## Proposal Request

**PROJECT:** *(name and address)*  
AWSOM  
Bentonville, Arkansas

# PROPOSAL REQUEST 092

## Gusset Plate Closures

**9 | 3200 LG CONFERENCE - SOUTH**  
1/4" = 1'-0"

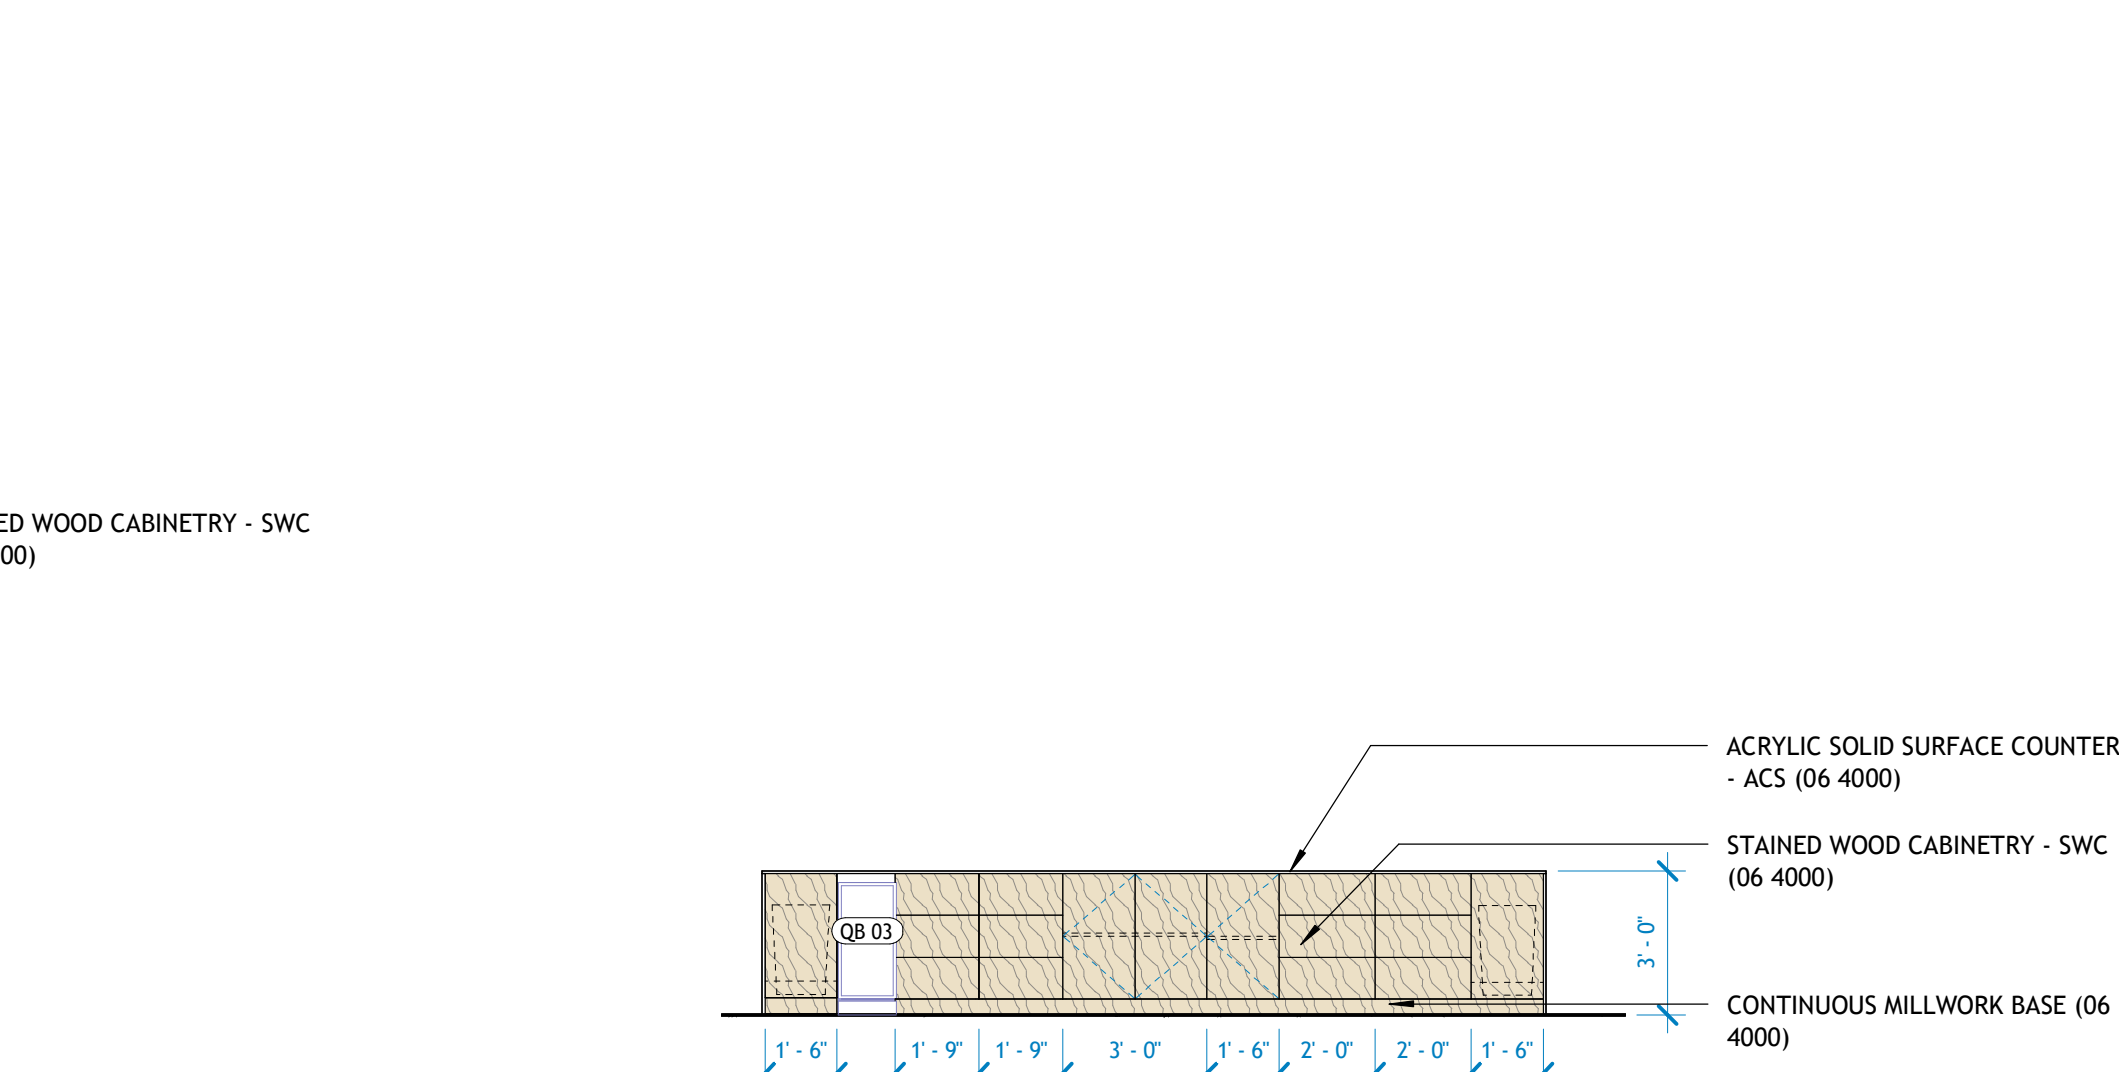
- (3) Add notes for MDF filler panels at Gussets.
- **DETAIL 9**
  - (1) Add gypsum furring wall in front of steel.
  - (2) Extend casework to side wall, with added note for 'angled condition.'
  - (3) Update west cabinet to match shop drawing markups for trashcan.

**10 | DYWIDAG CLOSURE - PLAN DETAIL**  
1 1/2" x 1'-0"

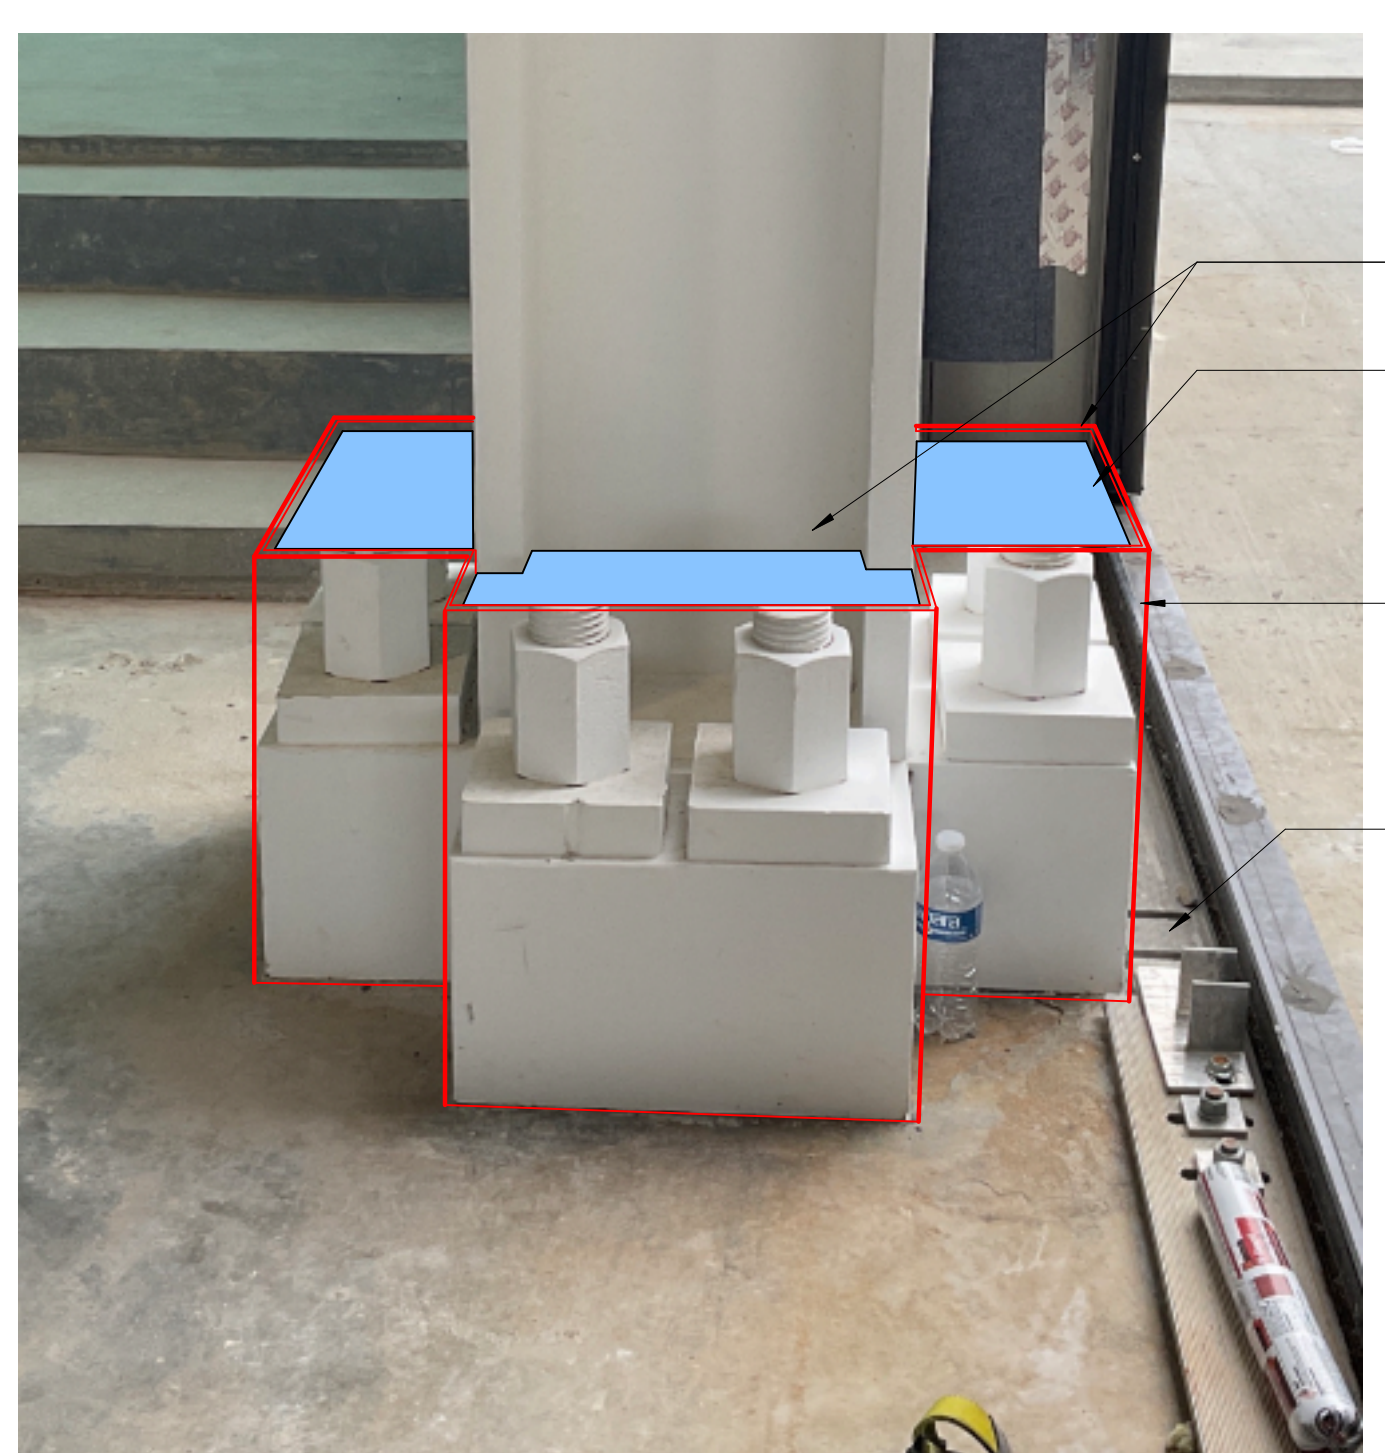
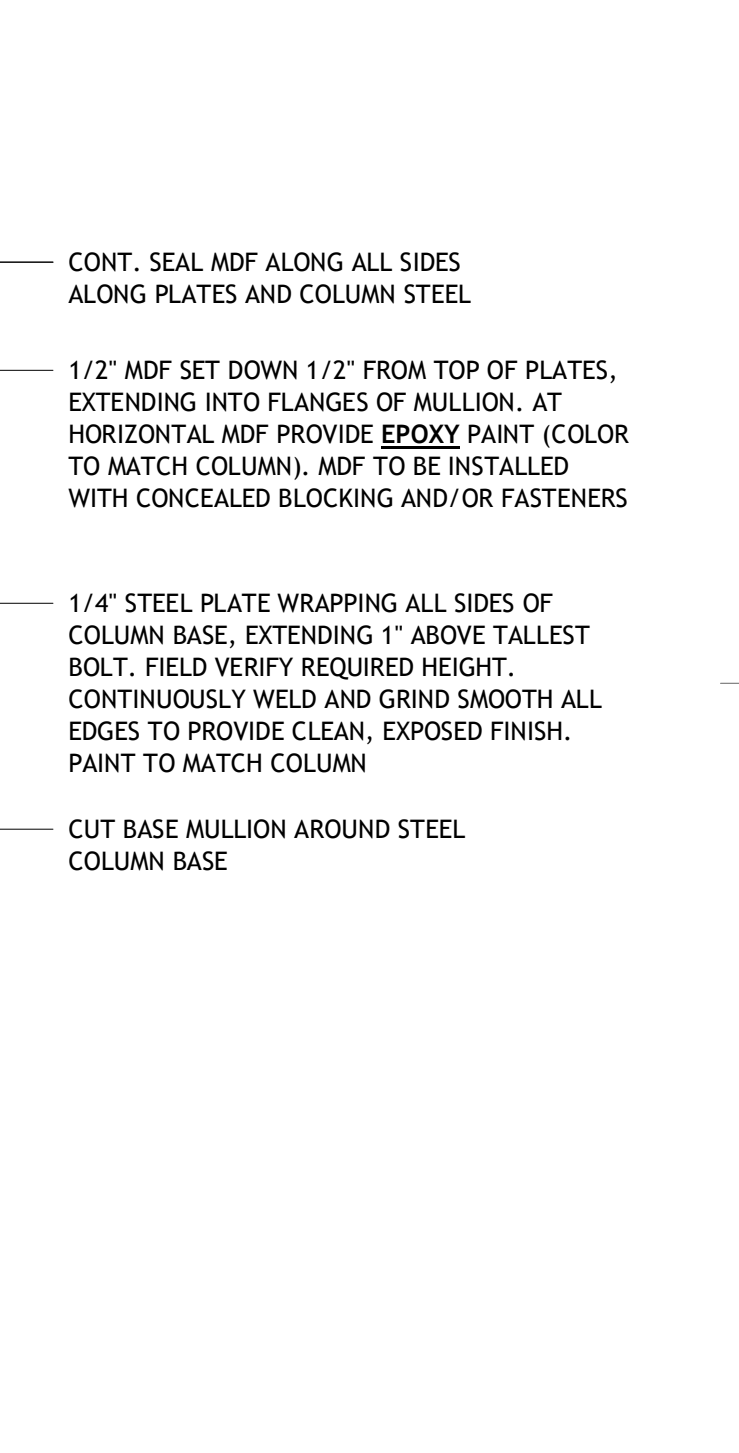
- g) Refer to Revised Sheet **A673** with original issue date 02.24.2023 and revision date **10.18.2024**.
  - Add details 10, 10A, 11, and 11B.
  - **Note to Crossland: Prior to Commencing with 10/10A, please use cardboard or similar method to mock this condition up (in-place) for owner approval of scale and overall effect.**

**9 MW SECTION - UPH BENCH3**  
3/4" = 1'-0"

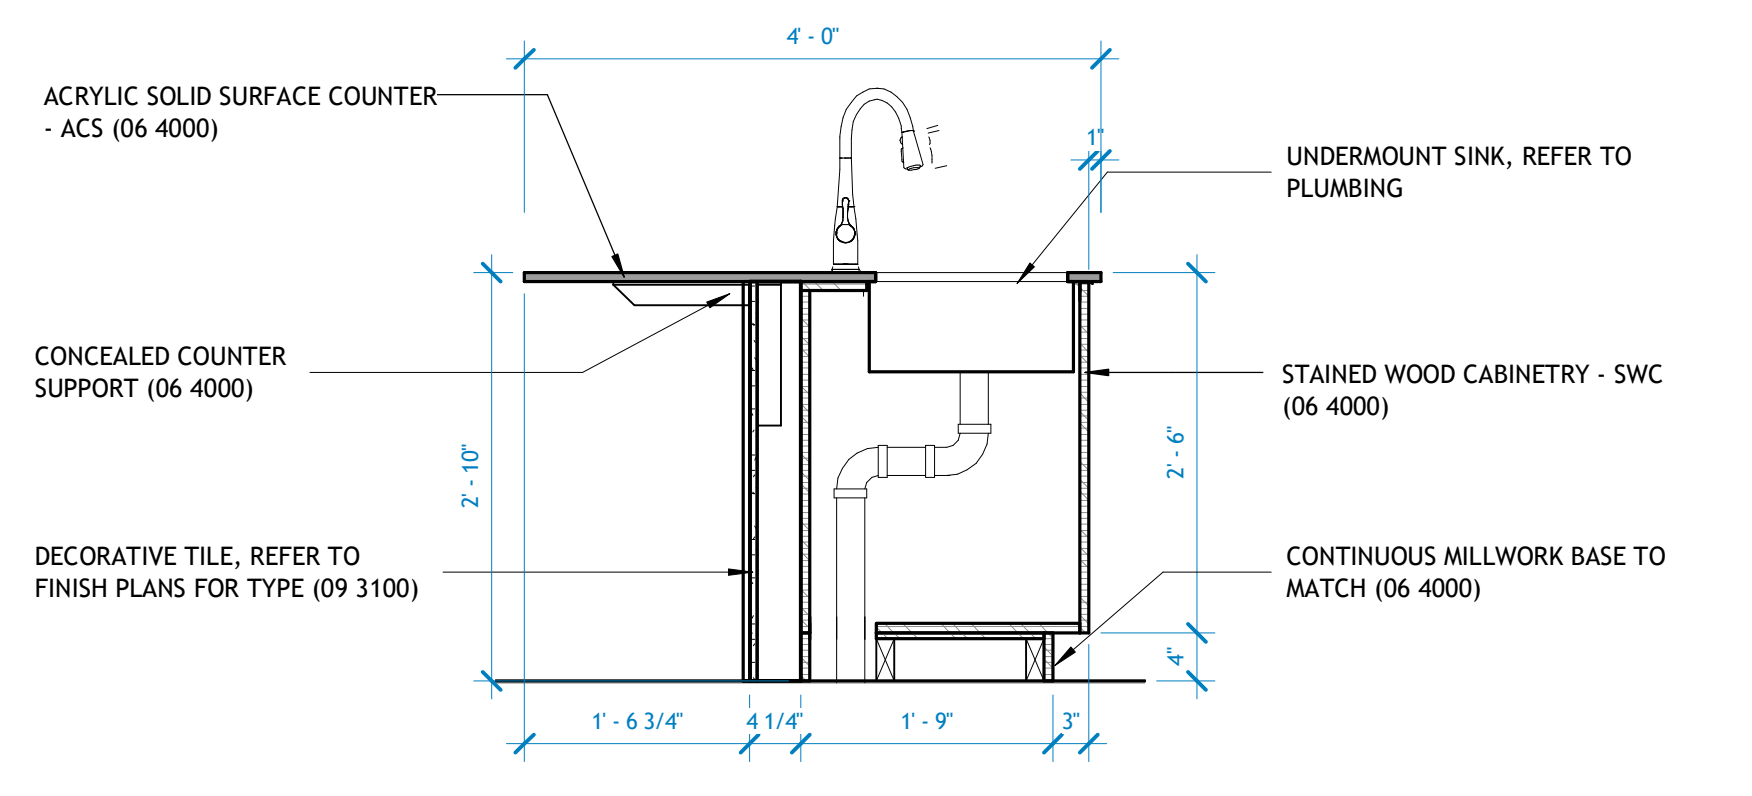
- h) Refer to Revised Sheet **A682** with original issue date 02.24.2023 and revision date **10.18.2024**.
  - **DETAIL 7**
    - (1) Add note for gusset plate condition.
    - (2) Revise width to account for varying conditions.
    - (3) Add note about removable cushion.
  - **DETAIL 8**
    - (1) Add note about removable cushion.
  - **DETAIL 9**
    - (1) Add note about removable cushion.
  - Add Details 15, 16, 17, 18, and 19.
